This 1:200 scale adjacency plan (based on SoA v8.0), which identifies the extent and departmental relationships and reflects the operational requirements of the departments within the 3Ts Project, is confirmed as agreed by the Trust, subject to the following caveats:

PROJECT TITLE
Brighton 3Ts

DRAWING TITLE
Room Relationships - Security Kiosk - Level B1 Stage 1

DRAWING TITLE
Room Relationship: Fracture and Imaging (Cold): Level 04 Stage 1

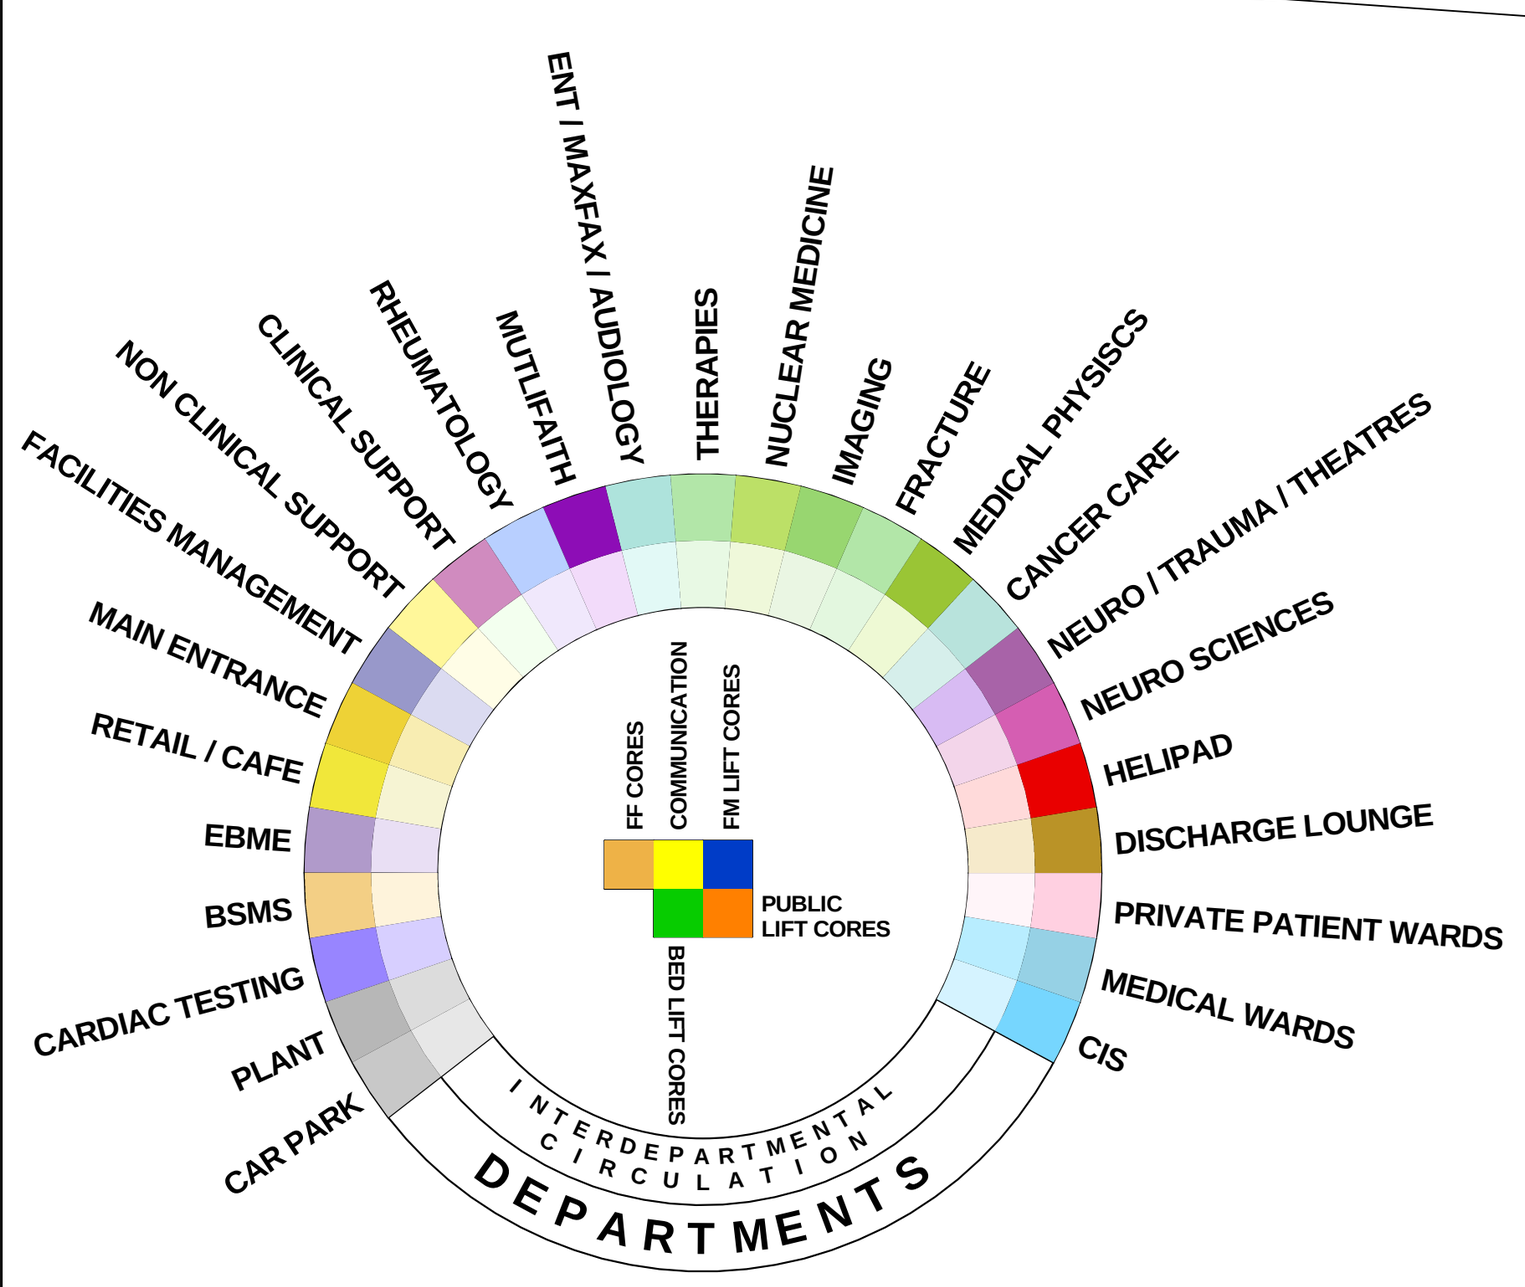
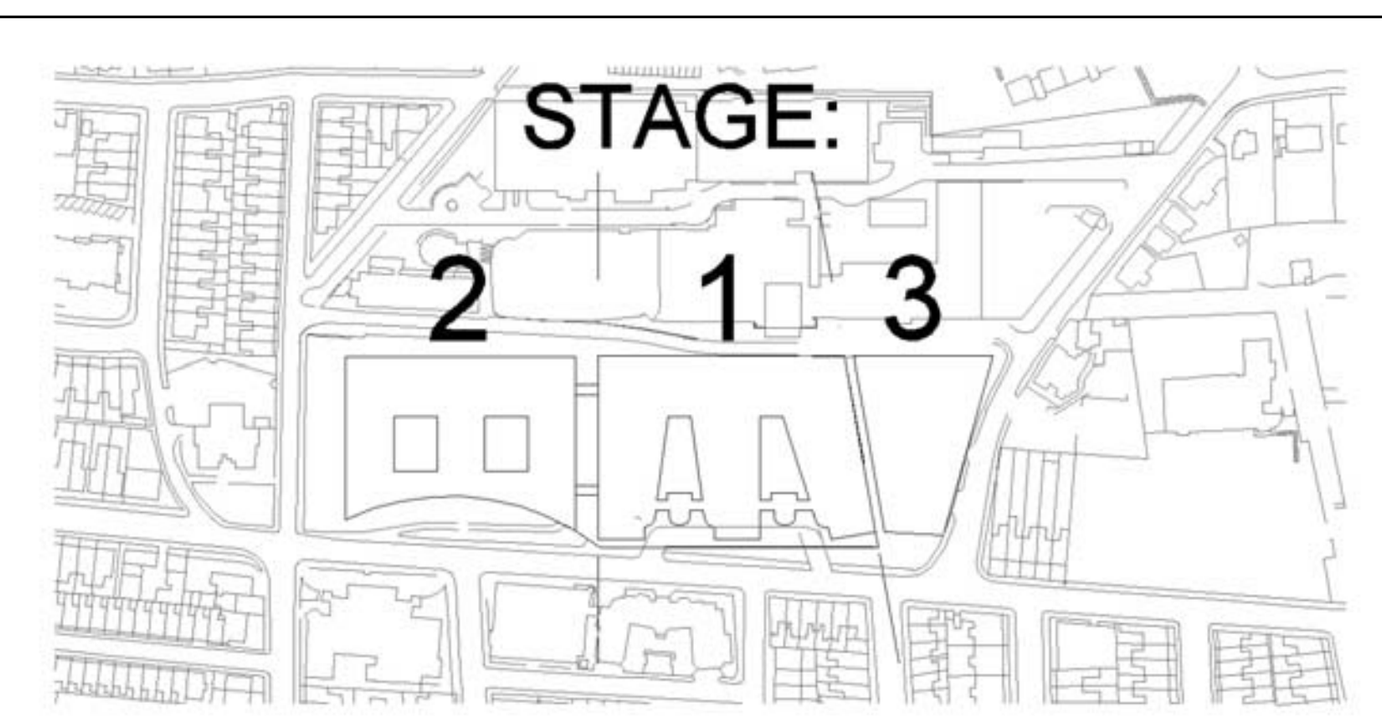
A 1 Person Snr Mngt Office in open plan, changed to enclosed office

B Window / Elevation co-ordination ongoing

C Door / Elevation co-ordination ongoing

D Removable panel / elevation co-ordination ongoing

DRAWING TITLE
Room Relationship: Hot Imaging - Recovery - Neurotheatres: Level 05 Stage 1

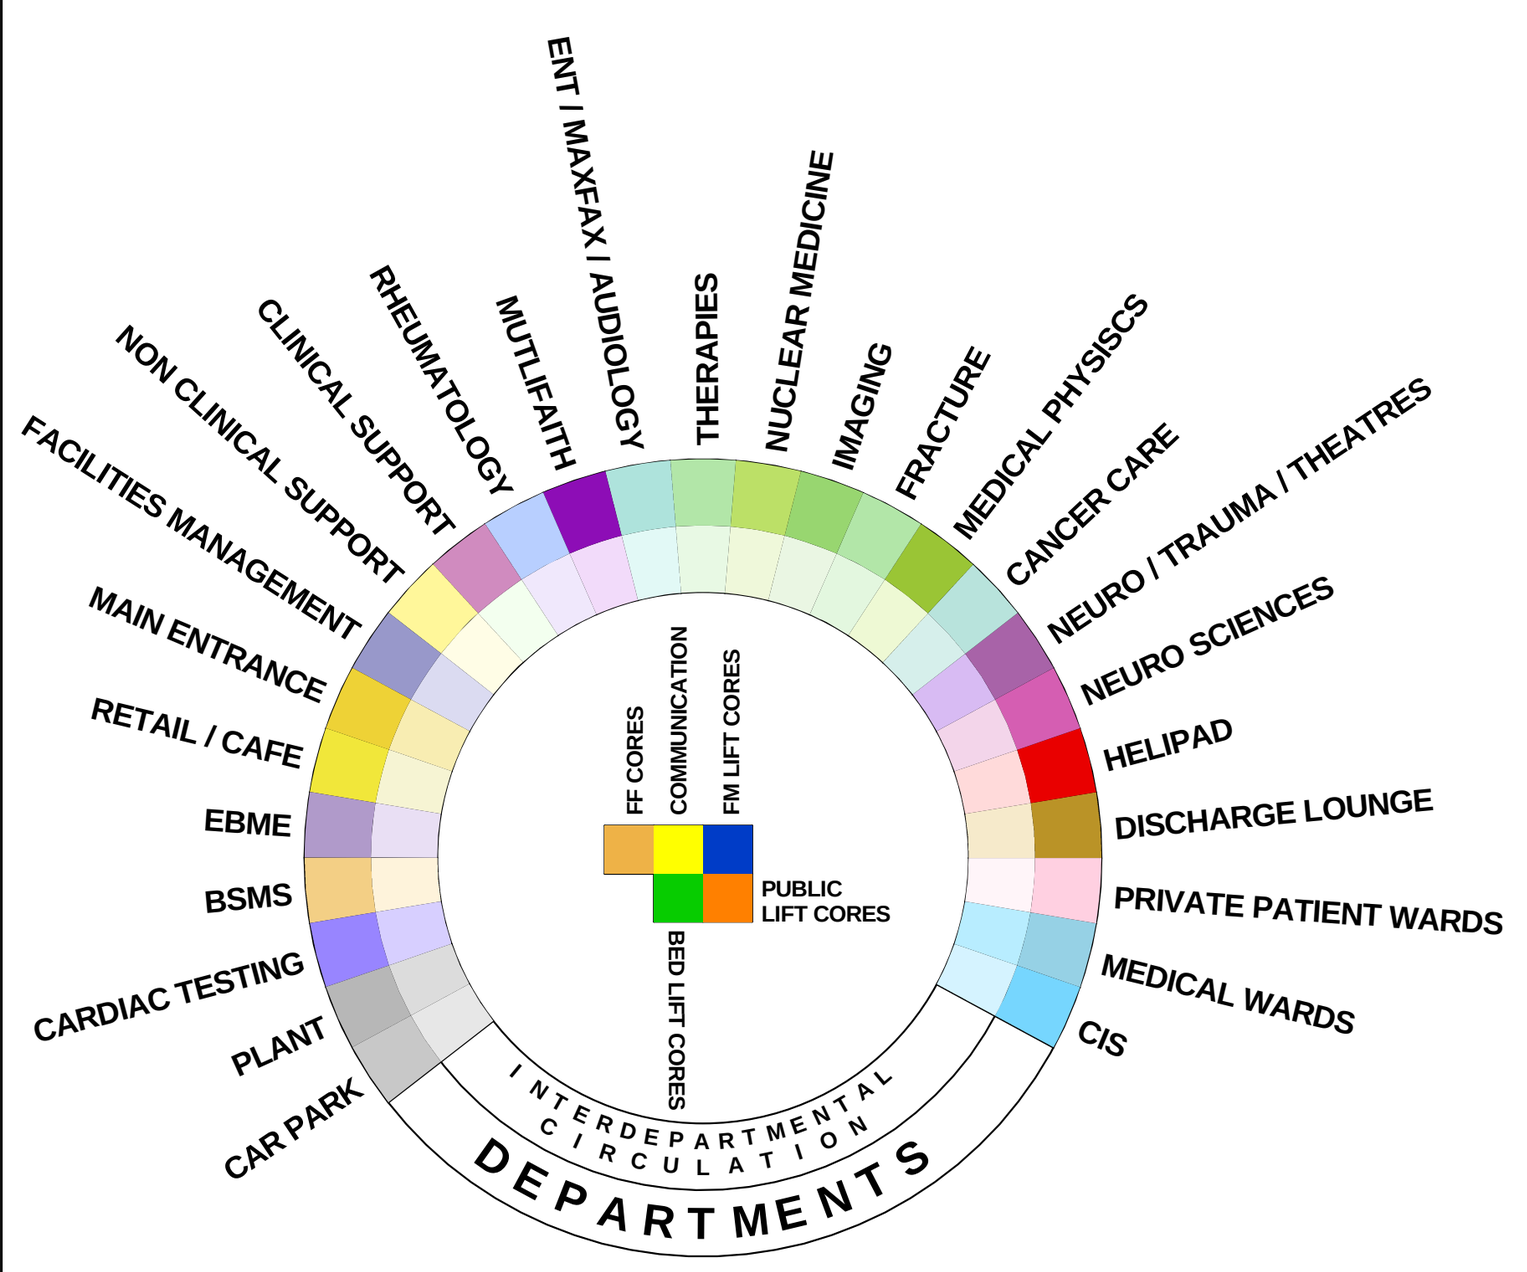
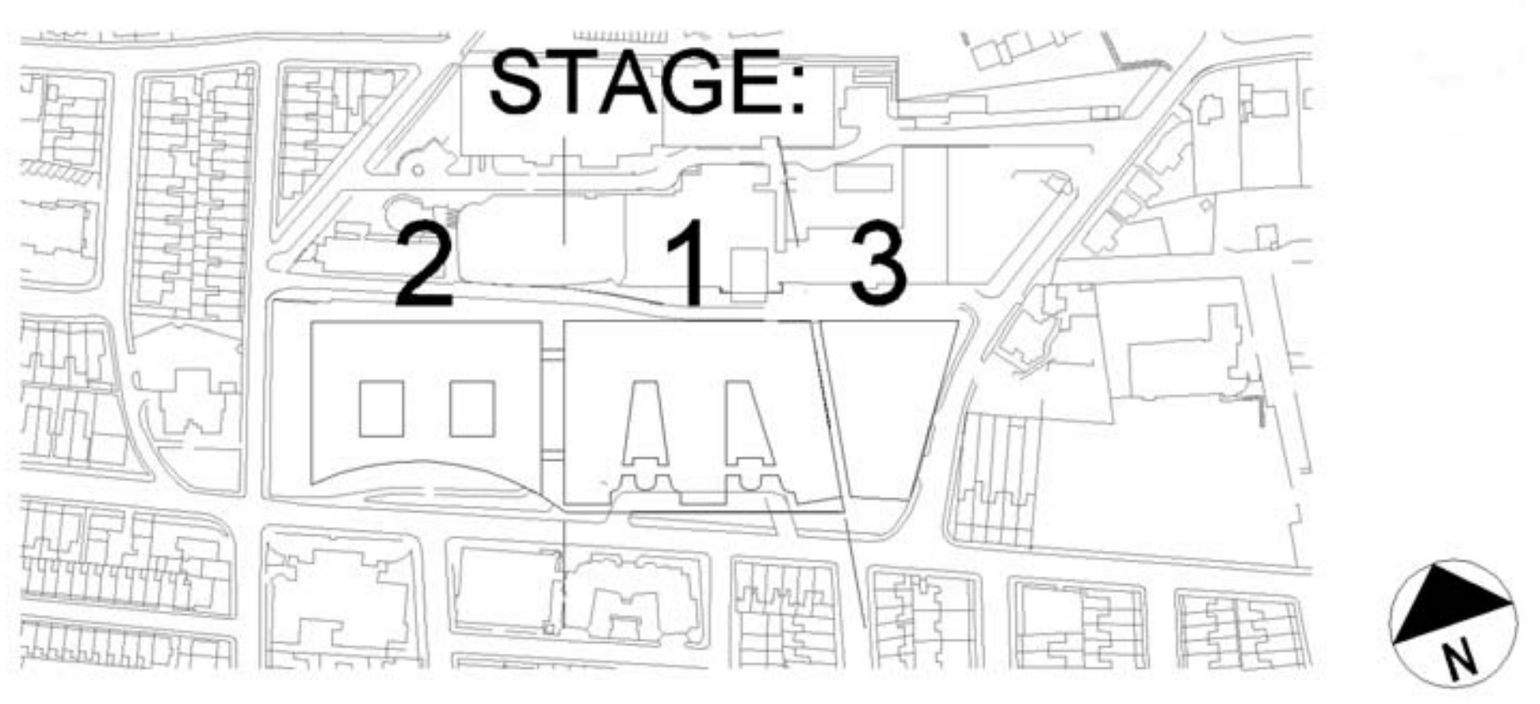
A IPS door added

B Ind Staff WC door updated

C Window co-ordination ongoing

DRAWING TITLE
Room Relationship: Medical Ward 80-Bed: Level 08 Stage 1

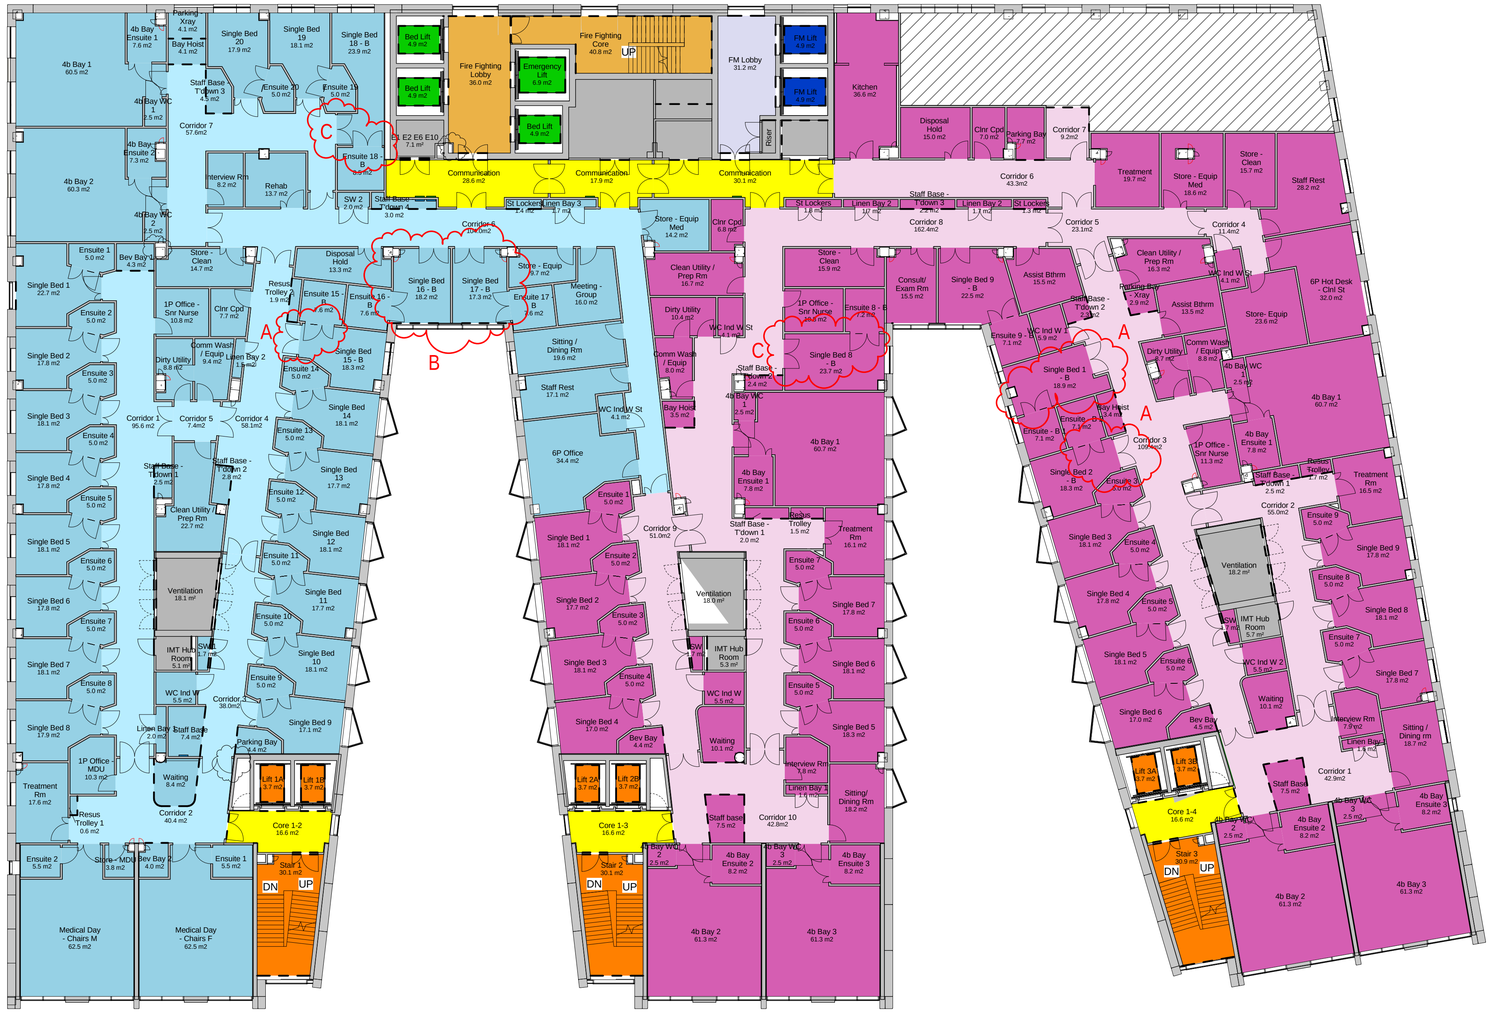
A Bariatric bedroom doors amended to open outwards, bariatric ensuite doors corrected to 1900 ensuite doors

B bariatric bedroom doors remain inward opening due to proximity of corridor and resultant overlap; bariatric ensuite doors not corrected to 1900 ensuite doors due to space constraints (1700 doors shown)

DRAWING TITLE
Room Relationship: Med. Ward; MDU/Neurosurgery Wards; Med. Ward St. Ch.; ADL; Level 09 St. 1

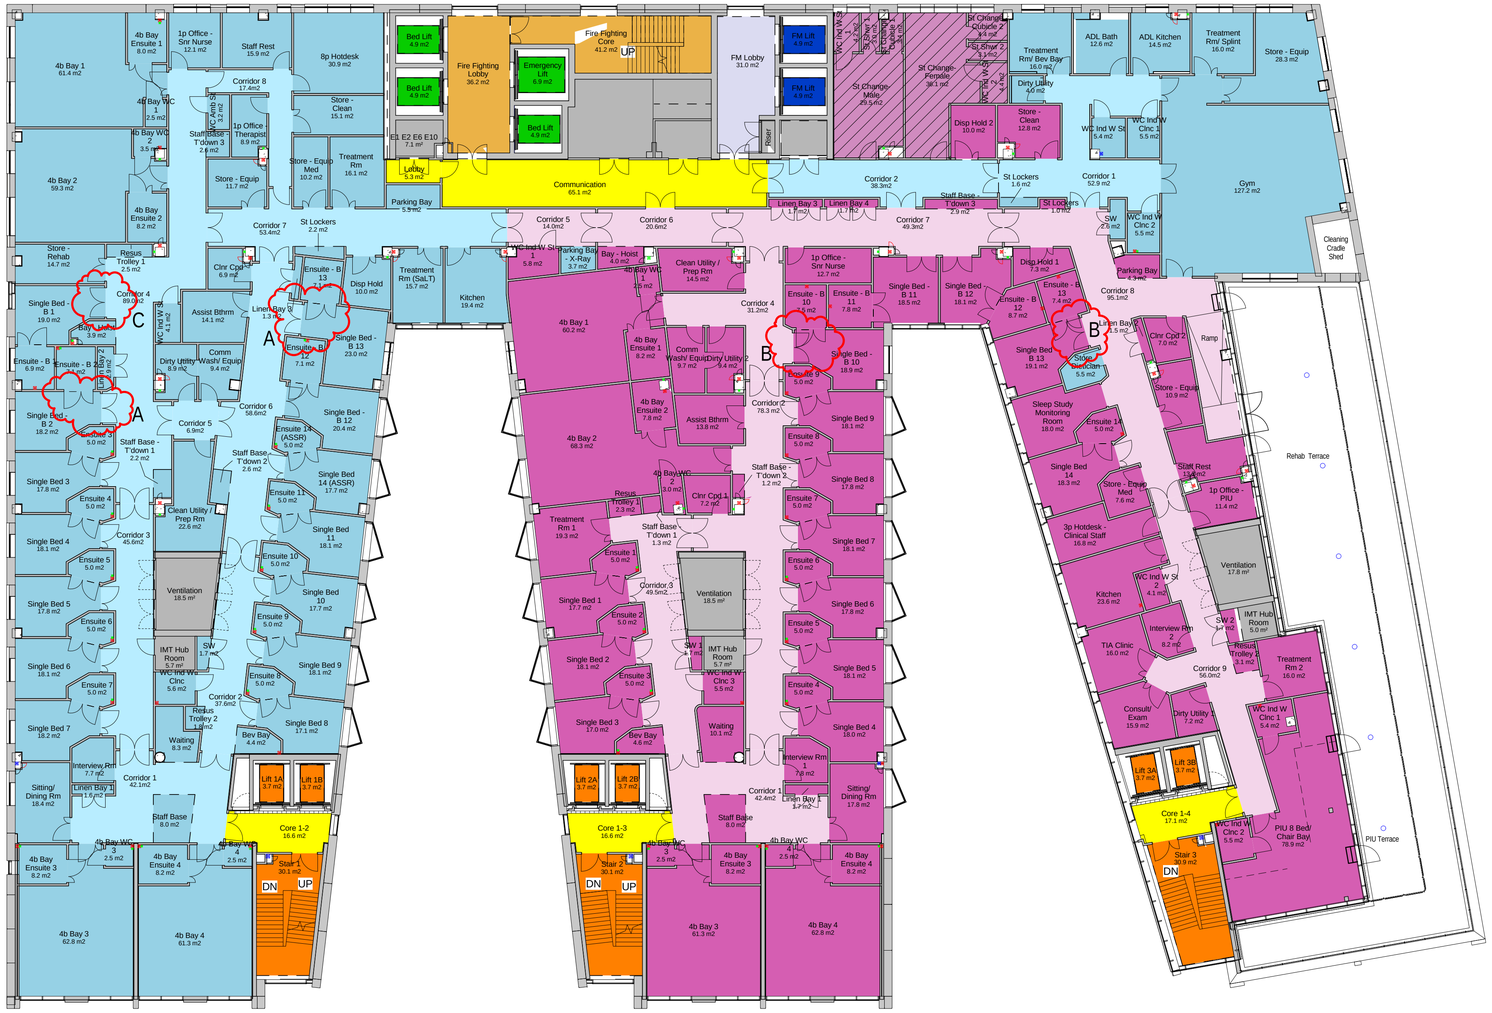
A Bariatric bedroom doors amended to open outwards, door set back and adjacent ensuite door location amended to suit

B Bariatric bedroom doors remain inward opening, due to proximity of adjacent rooms/doors and resultant overlap with corridor
